3				B	RE DRAWING	11-26
2	LEAD	ALLOY 42		A	RE DRAWING	8-27
1	CERAMIC	BLACK ALUMINA		φ	NEW DRAWING	MAY-12-1990
Rev	Name	Material	Description	Rev	Description	Date
UNLESS OTHERWISE SPECIFIED TOLERANCES: ± 1%			DRAWN	NWS TECHNICAL CERAMICS		
N. L. T. 2 DECIMALS. XX ± .01			CHECKED	NOK SPARK PLUG CO., LTD		
5 DECIMALS. XXX ± .008			APPROVED	TITLE		
CUSTOMER			UNIT	20 LEAD FLAT PACKAGE		
DWG			SCALE	DWG NO.		
				IFK20F1-2187A		
				SIZE		
				A-2		
				(0)

MODIFIED DWG No.

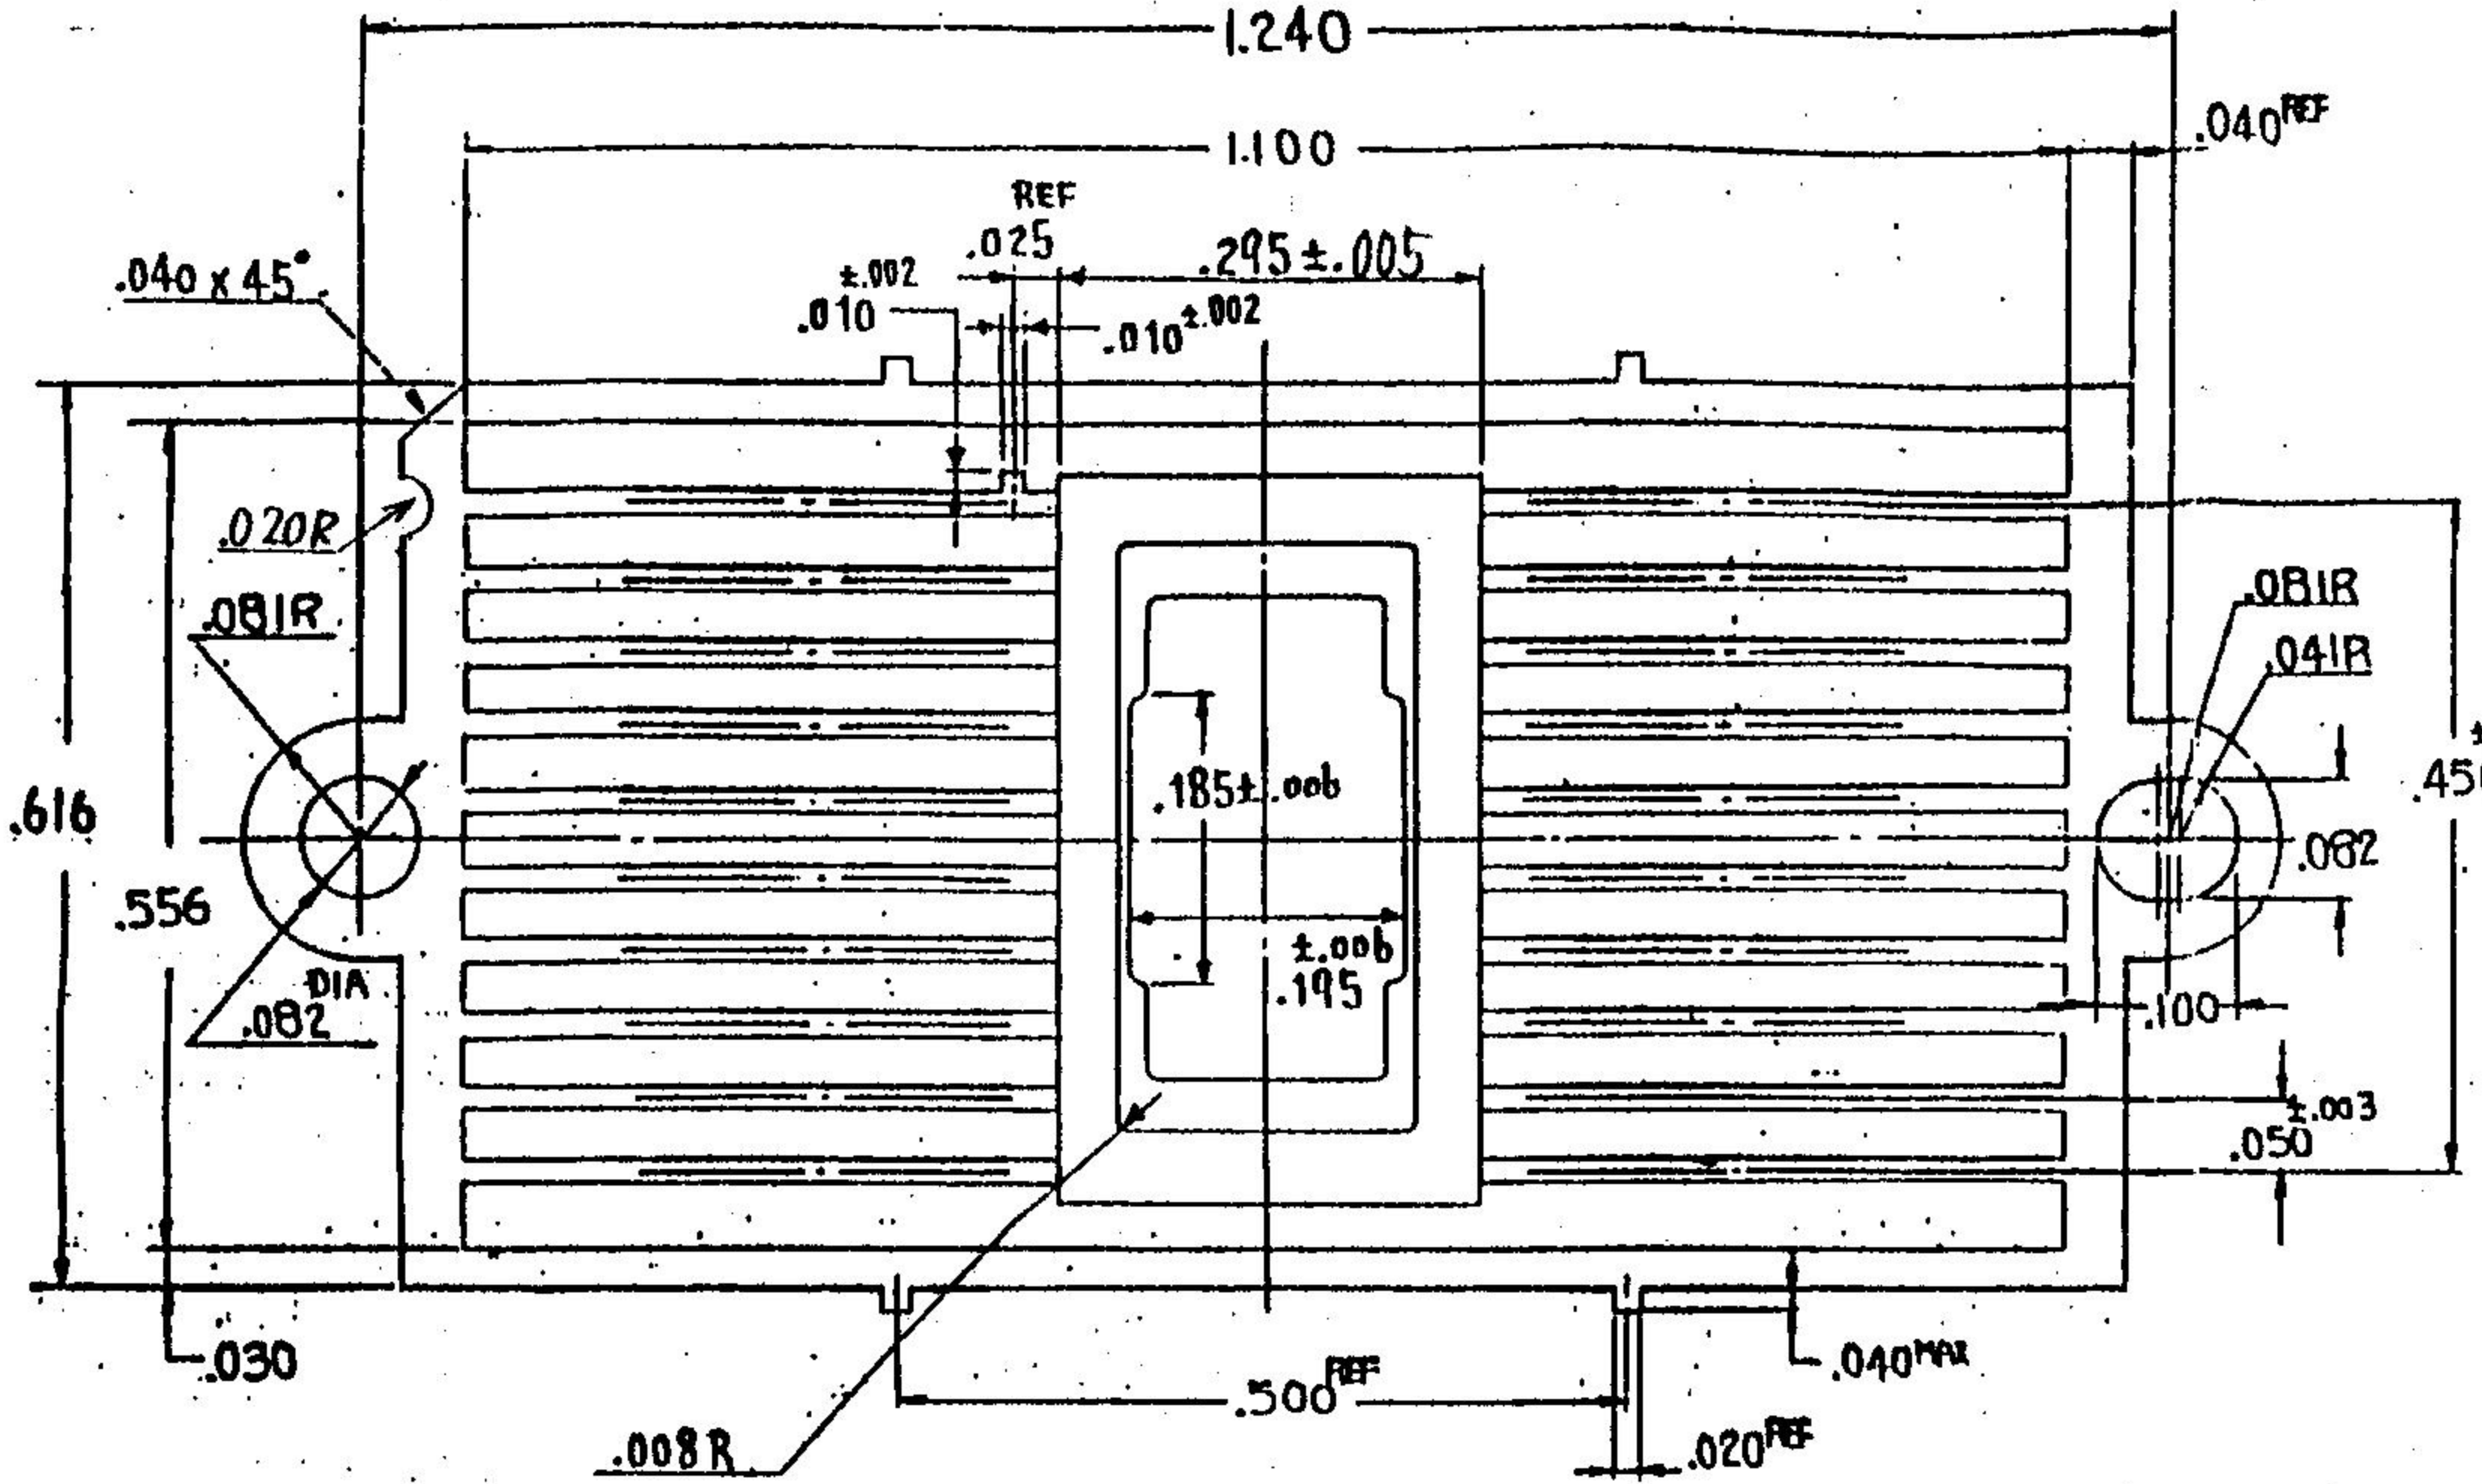
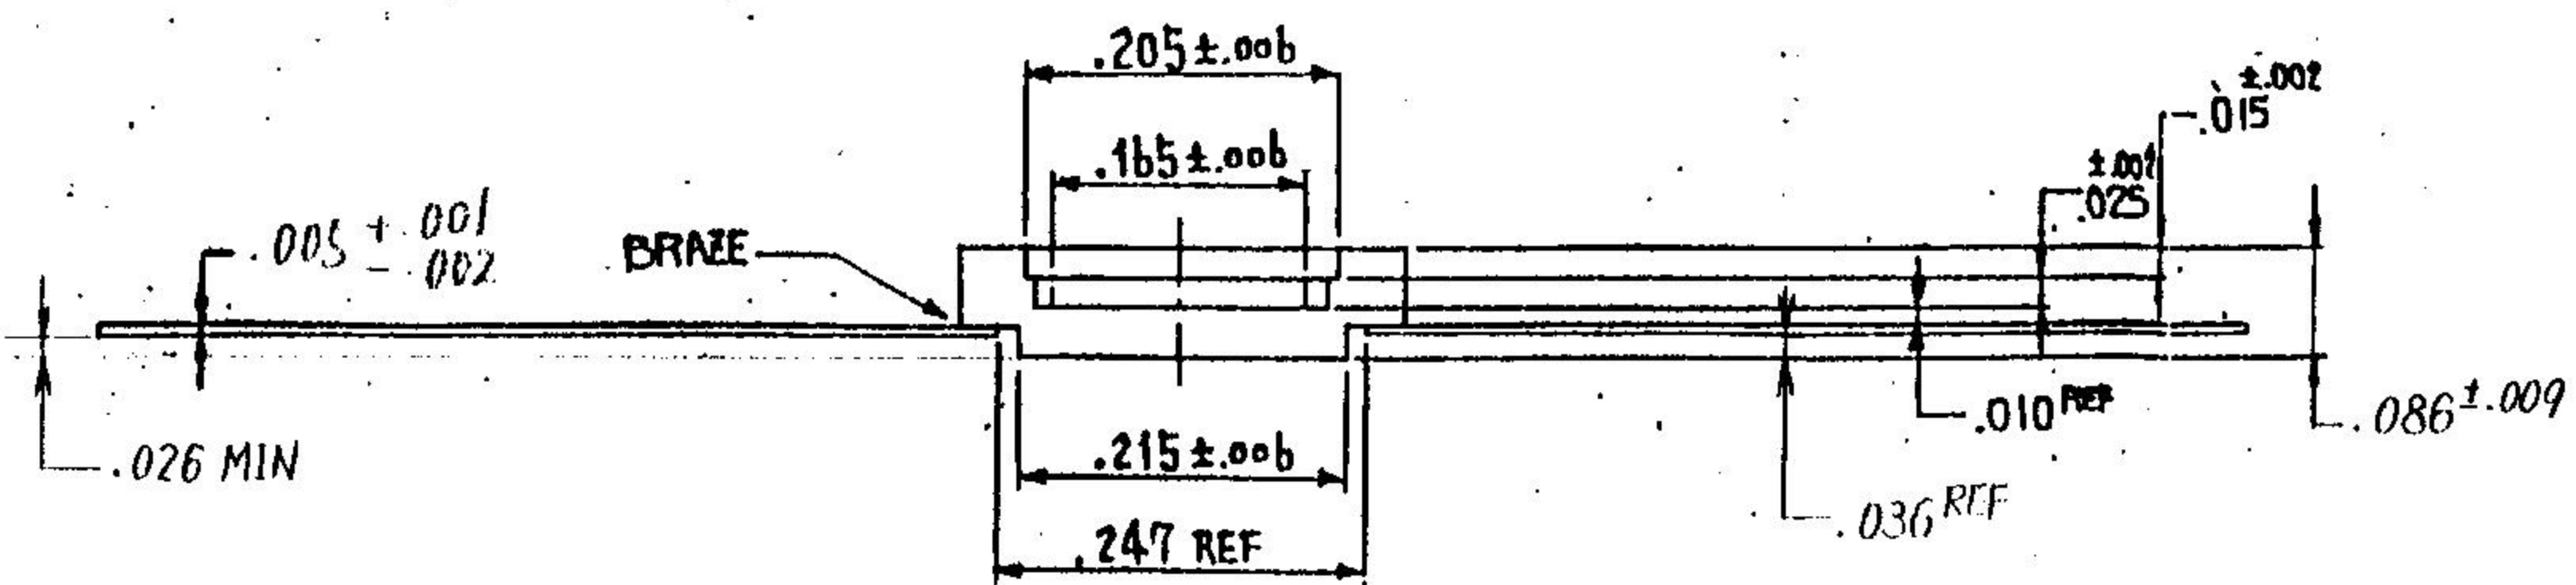
A CHANGE TOLERANCES.  
 .295 ± .005 WAS .295 ± .008  
 .005 ± .001 WAS .005 ± .002

B CHG L/F
